PRODUCT AFFECTED/TITLE  
PBX SYSTEMS  
NO. 756A  
PBX CABLING DIAGRAM

SHEET 1 OF 3	LDI ISSUE 418
CODE OR DOCUMENT IDENTIFICATION SD-65746-01	
SYSTEM PBX	<input type="checkbox"/> APPARATUS <input type="checkbox"/> EQUIPMENT <input checked="" type="checkbox"/> CIRCUIT <input type="checkbox"/> PROGRAM
<input type="checkbox"/> NEW <input checked="" type="checkbox"/> CHANGE	WECO ENGR LOC HAUTHORNE

PROJECT 756A PBX AT&TCO RATING STD

ON SHEET G3 SLIDE 2 PLUG C

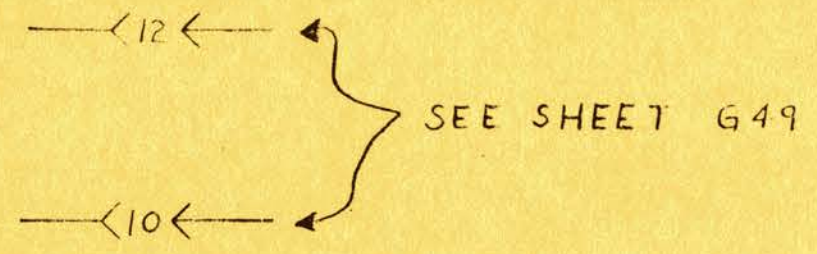
ITEM 1

REASON FOR CHANGE  
ITEM 1  
TO PROVIDE G AND H GROUNDS IN SLIDES 2 AND 4 FOR THE TRANSISTORIZED LINK TEST CIRCUIT.  
THIS CHANGE IS USED ONLY WHEN ISSUE 410 OR LATER IS REQUIRED.

LDI ISSUE 41B SHEET 2  
CODE OR DOCUMENT IDENTIFICATION  
SD-65746-C1

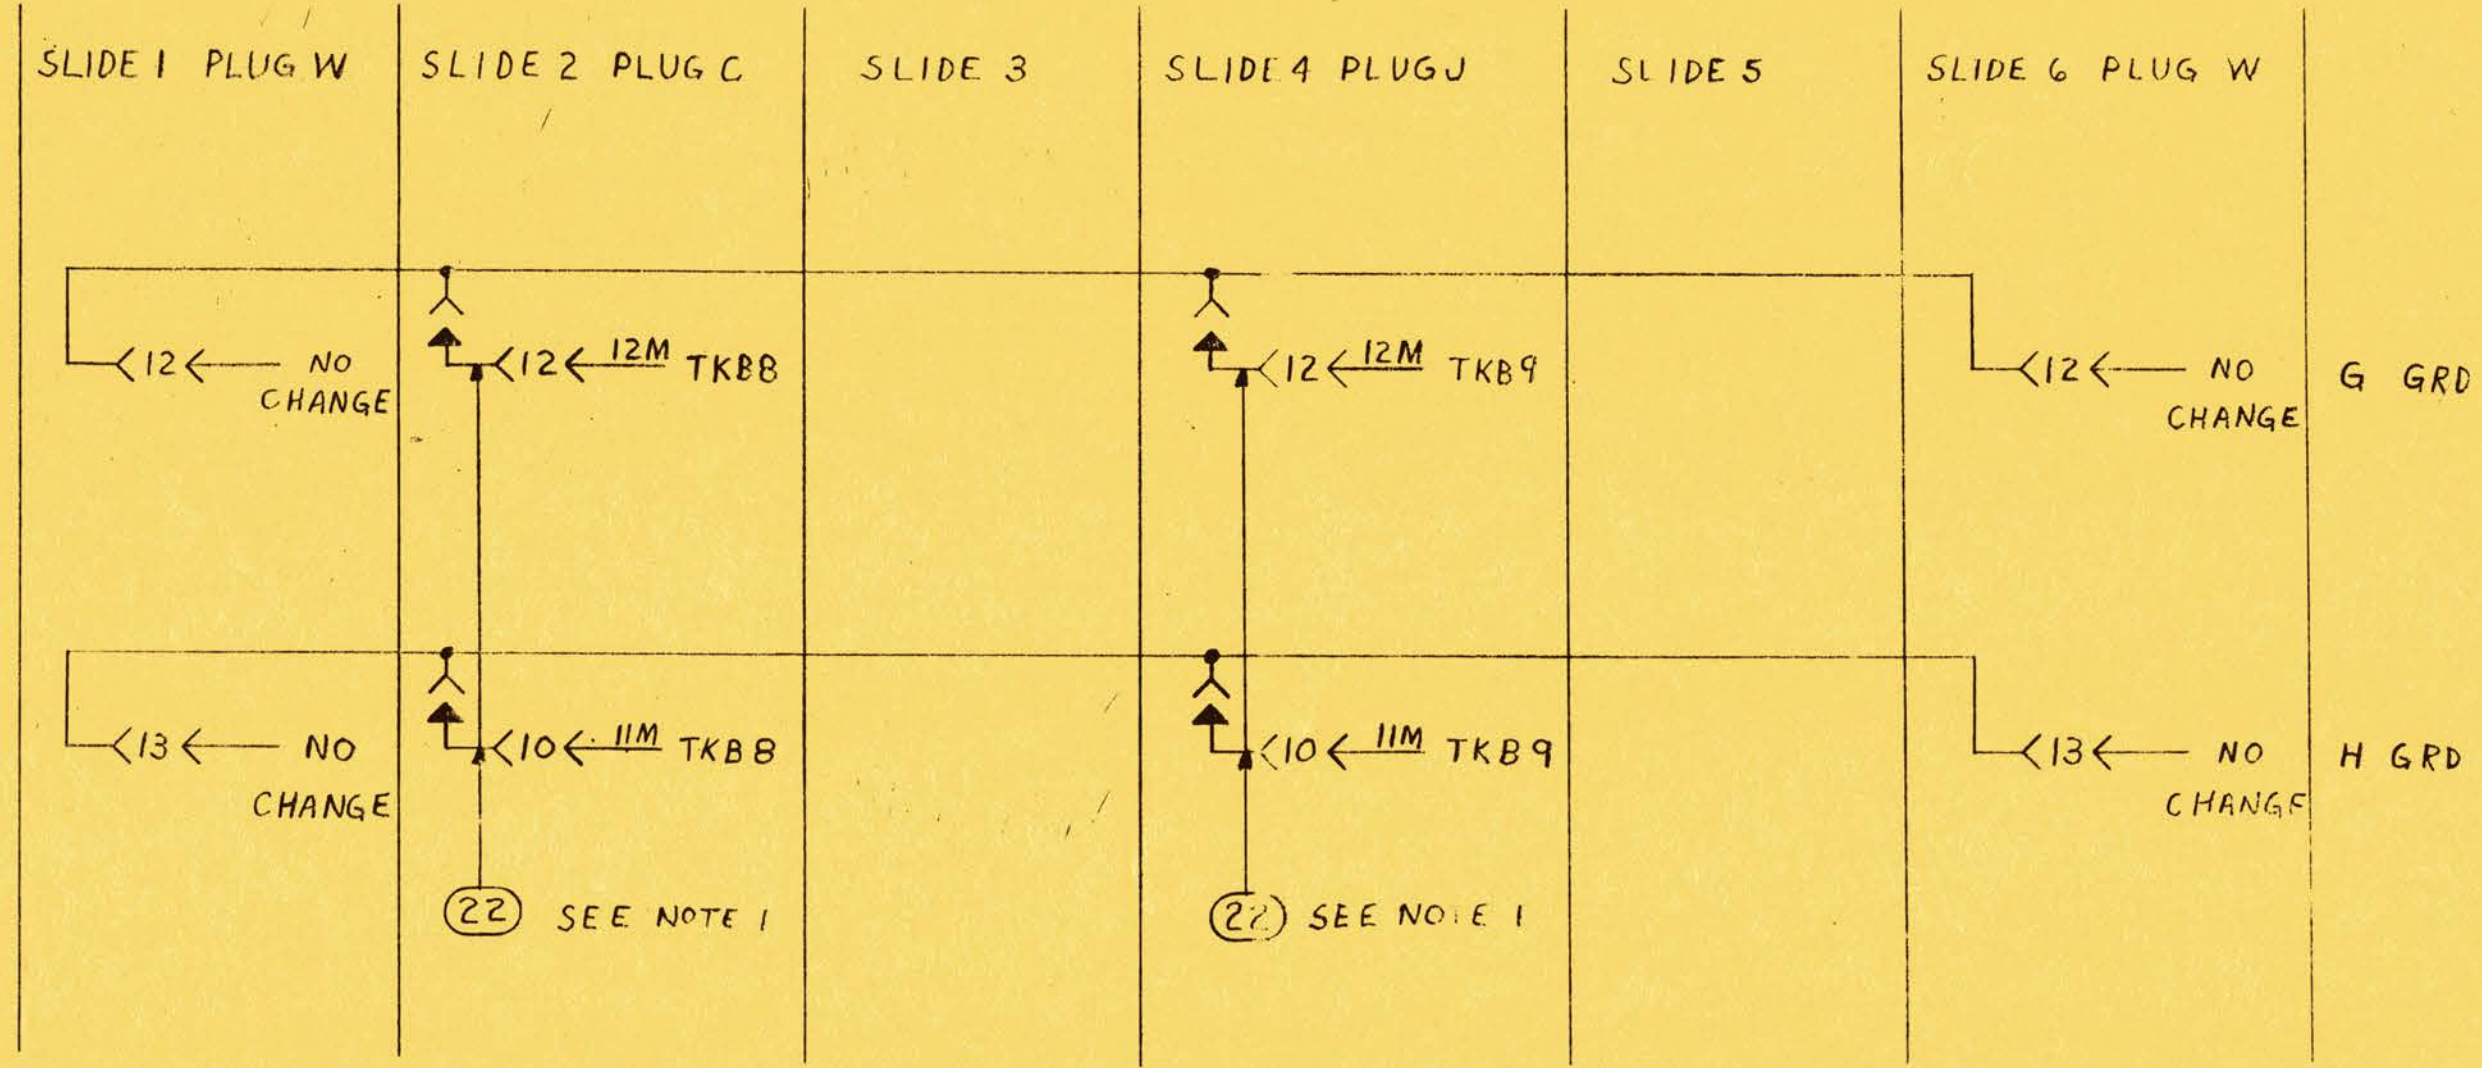
ITEM 1 CONT  
ON SHEET 649

NOTES:  
1. OPTION 22 IS SHOWN ON  
SD-65741-01.
